DEVELOPMENT APPLICATION ASSESSMENT REPORT

ITEM No.	
FILE No.	DA307/2015/1
ADDRESS	7-9 Ocean Street Woollahra (Emanuel Synagogue)
SITE AREA	3,996m ² (comprising five allotments)
ZONING	R2 Low Density Residential (existing use rights apply)
PROPOSAL (AS NOTIFIED)	Demolition of the Neuweg Chapel, administration building to the north of the Emanuel Synagogue, the child care centre to the south of Emanuel Synagogue and other associated structures (excluding 6 Woods Avenue) and the construction of a new basement car park for 14 vehicles with new vehicular entry and forecourt; a new two storey building to the north of the Emanuel Synagogue containing archives/meeting room, small sanctuary for approximately 30 people, learning centre, new lift and walkways and a new two storey building to the south of the Emanuel Synagogue containing a 60 space childcare centre and associated playground area, staff area, amenities, new lift and walkway and mid-size sanctuary for approximately 300 people and art gallery on the first floor level. The proposal also involves landscaping, new fences, ancillary structures and site works

Proposed play area

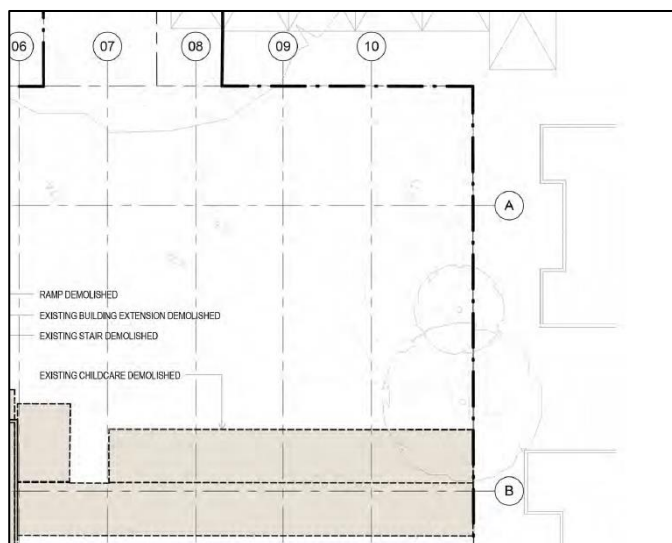
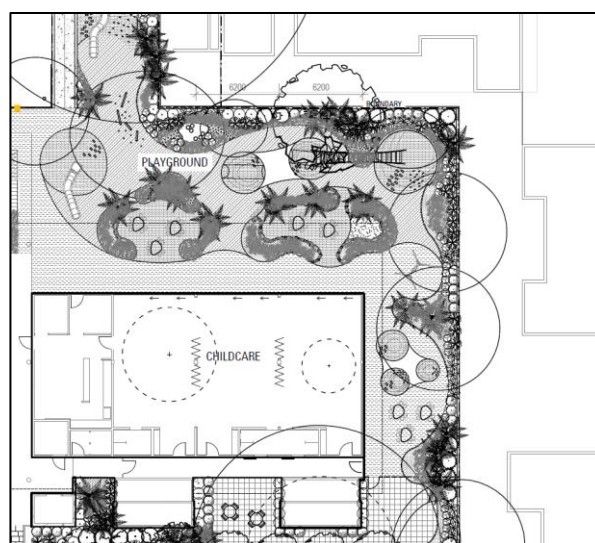
C1 requires indoor play area at the rate of 3.25m² per child with C2 requiring provision for a separate craft sink. The applicant has included the area of door swings in the calculation of the internal play area, which is not permitted in accordance with the Regulations. As a result, the proposal exhibits a non-compliance with C1 of 2m² that is required to be rectified in **Condition C1** with the relocation of the wall towards to the eastern boundary by 2m.

C4 requires separation between the active and open areas of the outdoor play area and neighbouring habitable room windows. With respect to the existing arrangement which has an expansive play area adjacent to six surrounding properties, the proposal maintains the status quo but achieves a more sympathetic design that allows improved screening to neighbouring residents. It is viewed that this is a net improvement in terms of separation and privacy.

C10 notes that outdoor play areas are to be to the north or north east of the site. This is not the case in this instance, with the play area to the east and south of the building. Some is also located within the undercroft space. This is a positive arrangement as it allows for shading of some areas but with ready access to sunlight along the eastern side in the morning period. Adequate daylight will be provided to most areas.
